**Design Review Board Case #2014-0004**  
**315 Stoval Street – Hoffman Block 2 – TSA**

Application	General Data	
<p><b>Project Name:</b> Hoffman Block 2 – TSA Center</p> <p><b>Location:</b> 315 Stoval Street (Block 2)</p> <p><b>Applicant:</b> The JBG Companies, Inc, Represented by Cathy Puskar</p> <p>Architect: HOK</p>	<b>DRB Date:</b>	December 18, 2014
	<b>Site Area:</b>	3.27 acres
	<b>Zone:</b>	CDD#2
	<b>Proposed Use:</b>	Office
	<b>Proposed Gross Floor Area:</b>	661,387 sf
<p><b>Purpose of Application:</b></p>		
<p>Stage II DSUP for an office building with above grade structured parking for the Transportation Safety Administration on Block 2 of the Eisenhower East Small Area Plan.</p>		
<p><b>Staff Reviewers:</b> Thomas H. Canfield, AIA <a href="mailto:tom.canfield@alexandriava.gov">tom.canfield@alexandriava.gov</a>            Robert Kerns, AICP, <a href="mailto:robert.kerns@alexandriava.gov">robert.kerns@alexandriava.gov</a>            Gary Wagner, RLA, <a href="mailto:gary.wagner@alexandriava.gov">gary.wagner@alexandriava.gov</a>            Trey Akers, Planner II, <a href="mailto:trey.akers@alexandriava.gov">trey.akers@alexandriava.gov</a></p>

Illustration A

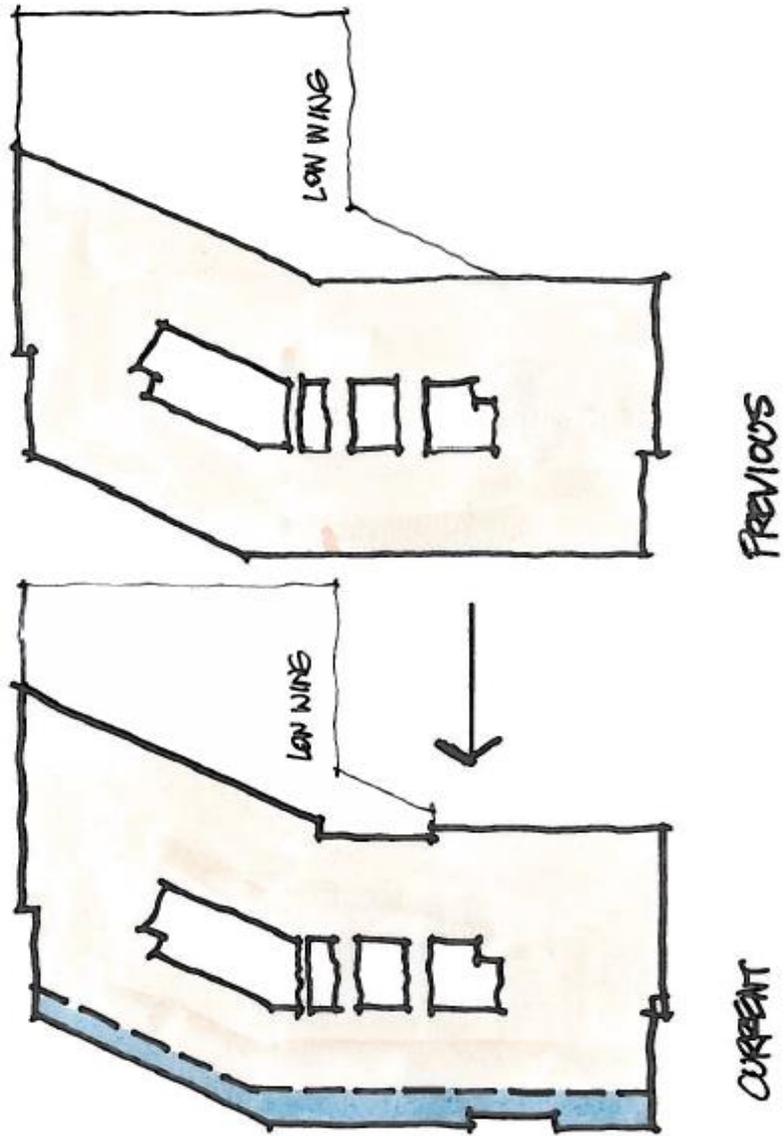
The typical floor plate has been enlarged since the last DRB meeting, and the tower height has been reduced by one floor (see Illustration A). The result is an even squatter-proportioned massing. This problem is compounded by the use of the same building skin on all sides, such that the entire form, in spite of its minor ins and outs in plan, reads as a single, heavy mass, with a flat top and a prominent mechanical penthouse.

Illustration B

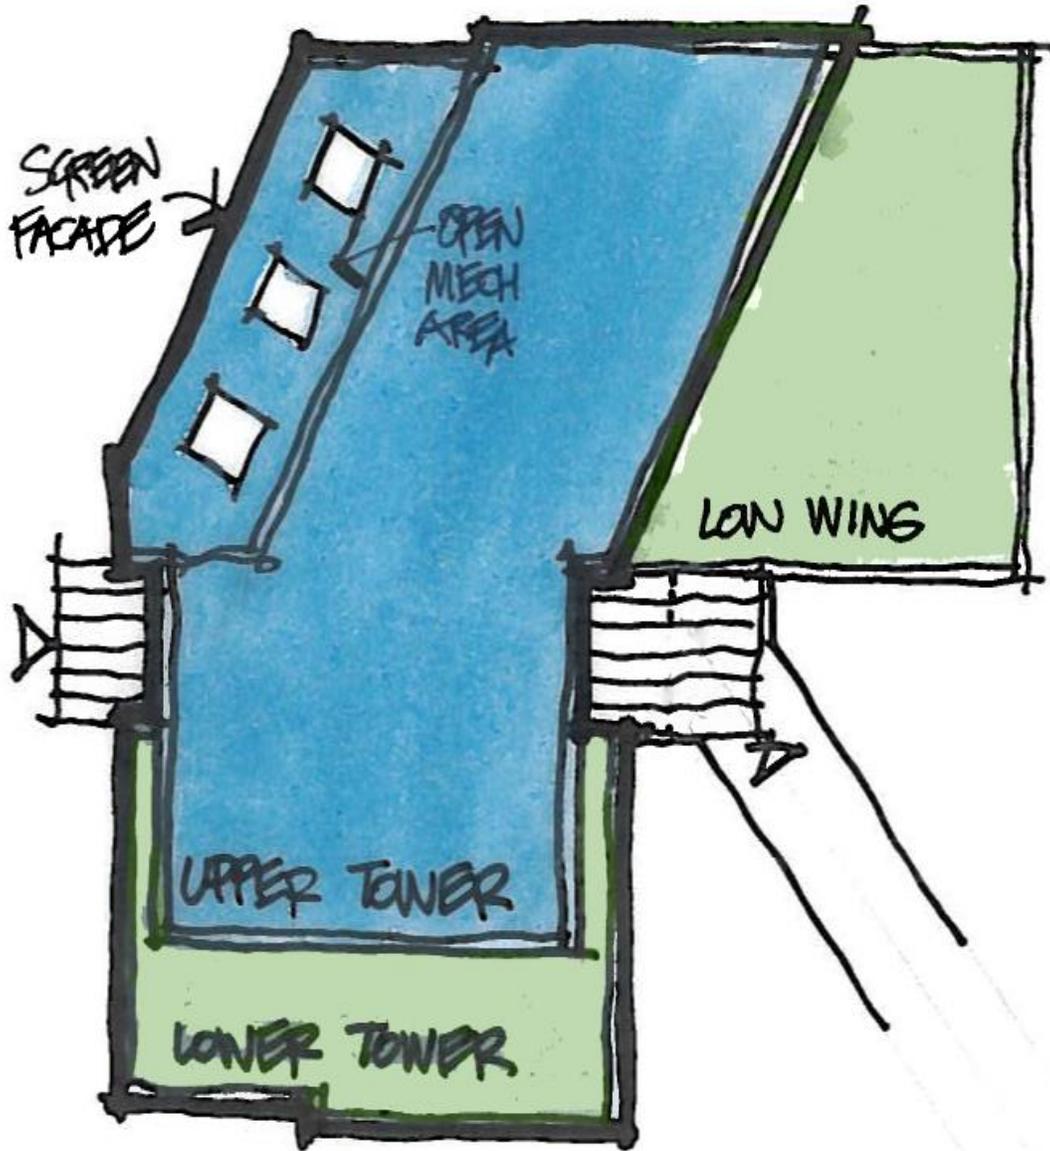
In order to create a more elegant and vertical expression, staff recommends that the tower form be much more strongly articulated. This could be accomplished by breaking the mass down into two smaller, more vertical components, one of which could absorb the elevator and mechanical components and rise a story or more above the lower piece. Using a different, but

related, skin treatment for each of the two components would further refine the proportions of the tower. This would accomplish a number of goals: more variety in height and mass; a strong skyline; and integration of otherwise distracting mechanical and elevator functions, while potentially creating a large, useable rooftop open space on the lower tower half (see Illustrations B & C).

Illustration D

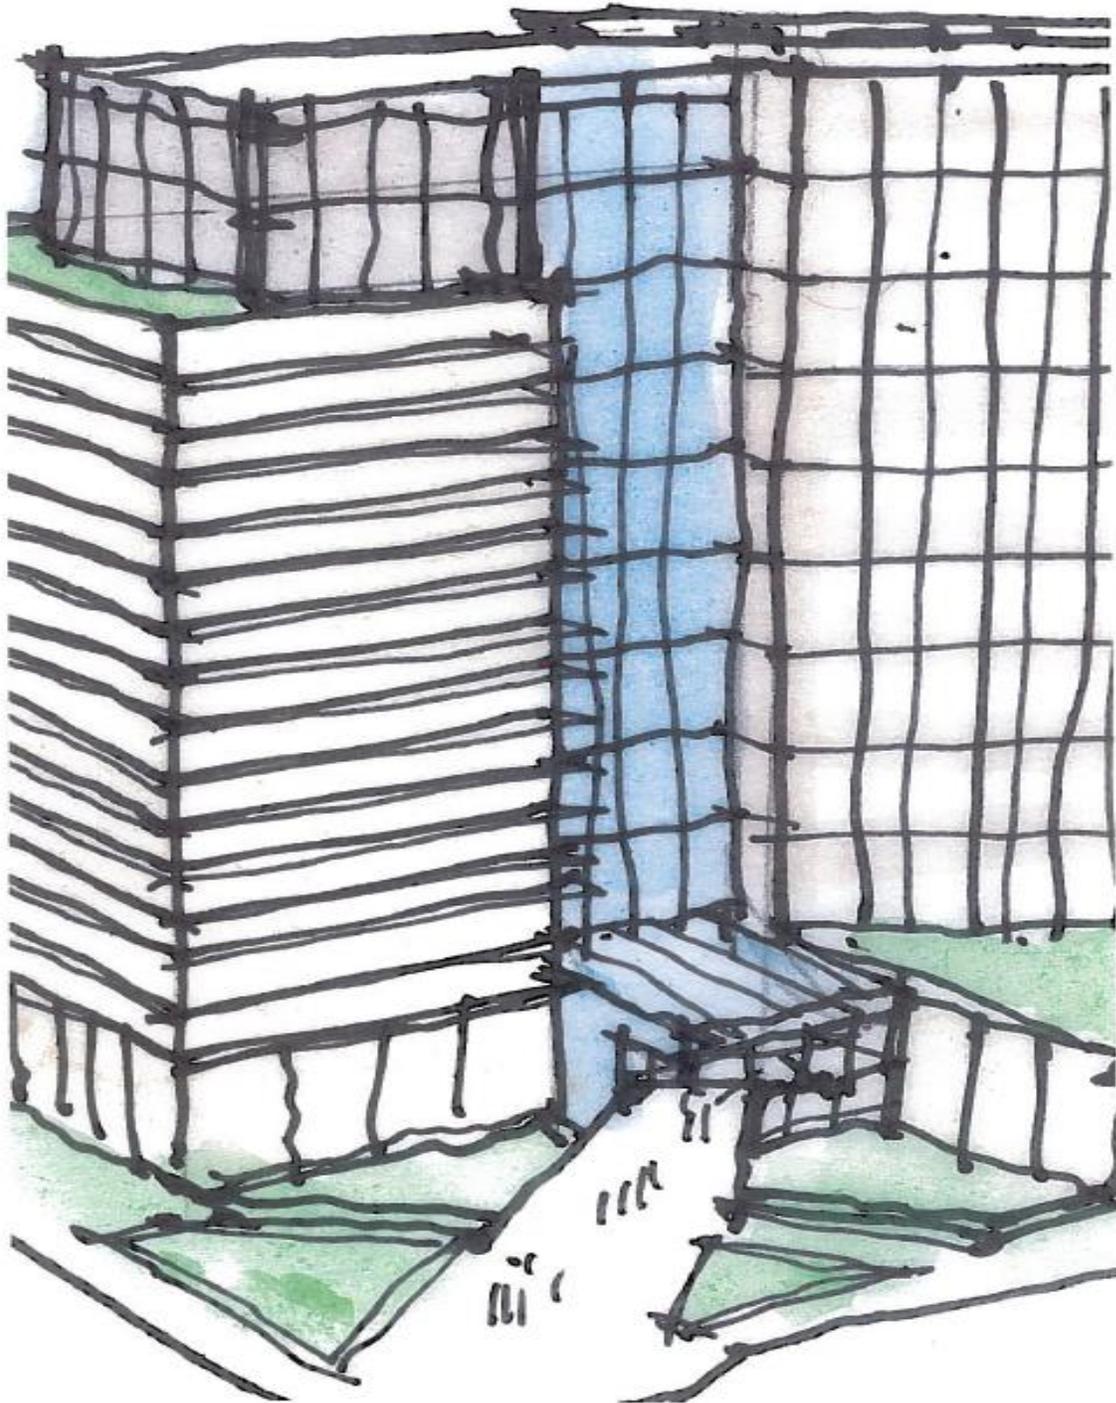
Finally, the two low rise elements, including the large two story north wing that faces Stovall and Pershing, and the smaller glass “knuckle” at the building entry, appear to be completely unrelated to the rest of the building visually. Their design should be integrated with the overall concept for form and cladding. For example, the entry “knuckle” could be resolved as an evolution and outgrowth of the building hyphen facing east, while the large north wing could be either an integral part of the tower skin vocabulary, or read as a more solid plinth or base element (see Illustration D). Either way, both of these components read as tacked on in the current design.

Illustration E

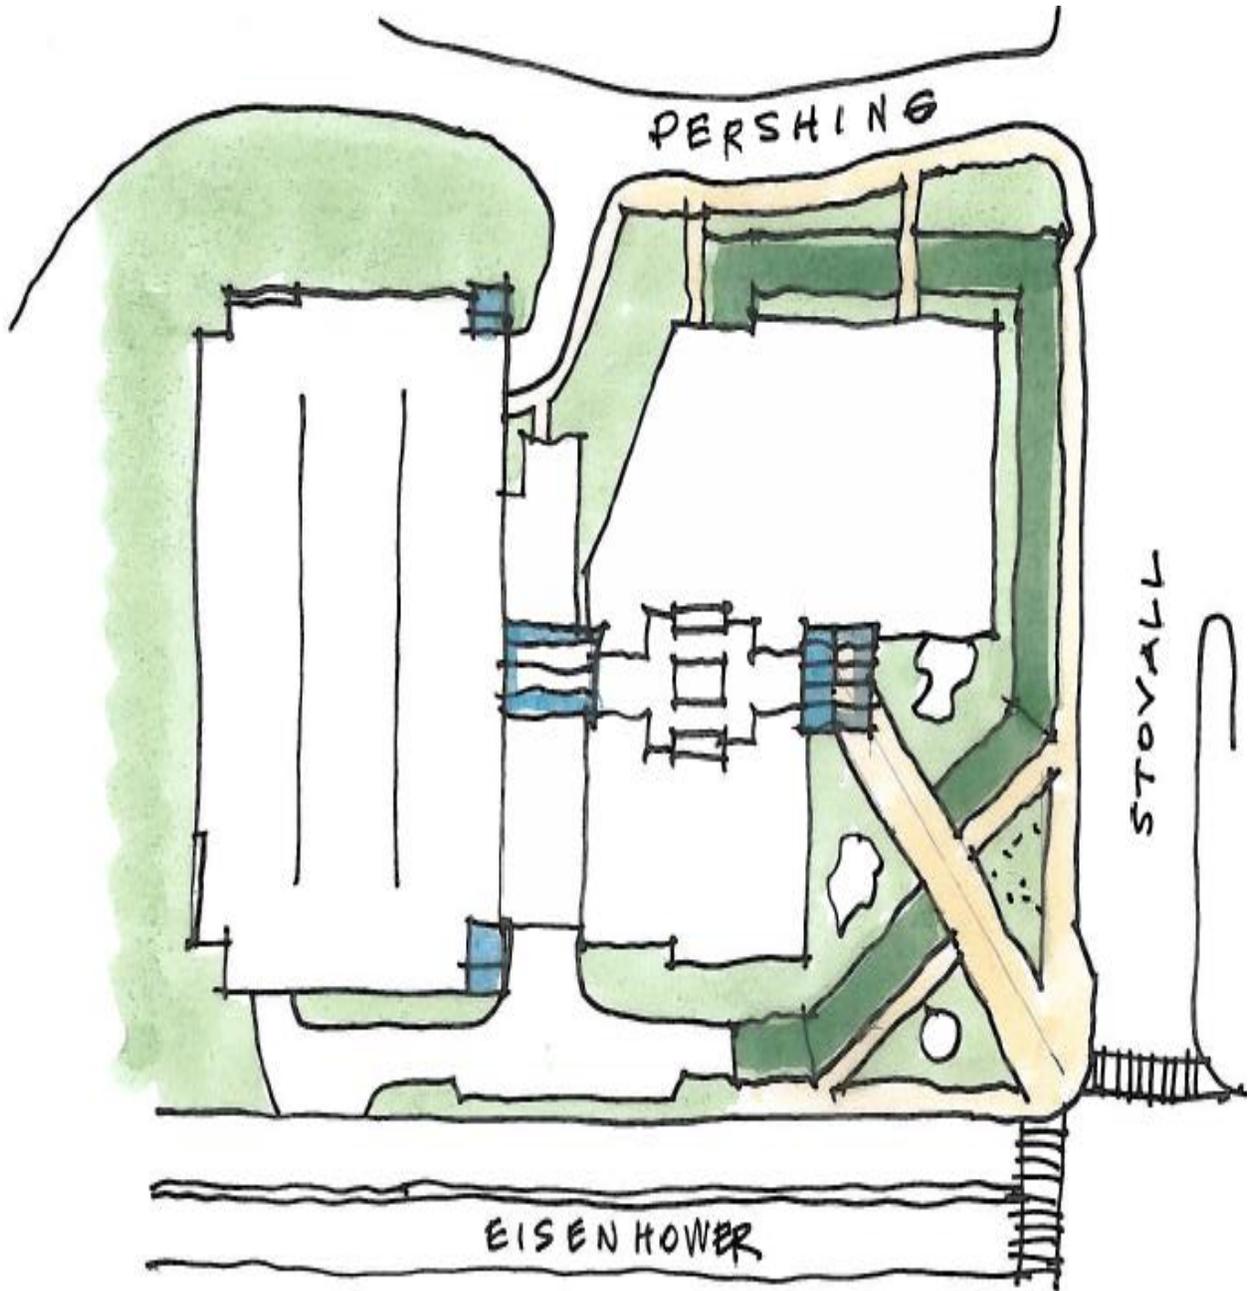
Staff continues to have concerns about the lack of a geometric relationship between the entry “bridge” and the pedestrian arrival point at the corner of Eisenhower and Stovall, and points out that the rotation of this element *away* from Eisenhower has also resulted in a strongly pinched open space at the garden level to the north of the bridge. There is an opportunity to create a strong urban pedestrian connection here, which has not been fully realized (see examples, Illustration E).
